Bulletin No.: 13420A Date: May 2014

PRODUCT SAFETY RECALL

SUBJECT: Fuel Transfer Pump Malfunction

MODELS: 2012-2013 Chevrolet Silverado Chassis Cab

3665769

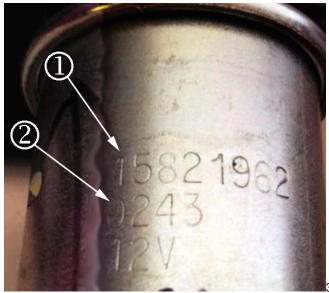
2. Determine the fuel transfer pump date code. Locate the 4 digit date code number (2) that is below the part number (1). Replace any fuel transfer pumps with the following date code numbers: 0612 – 3662 or 0013 – 1213. The first three numbers are the Julian date of the year and the last number is the year. Example: 0612 = 3/1/12.
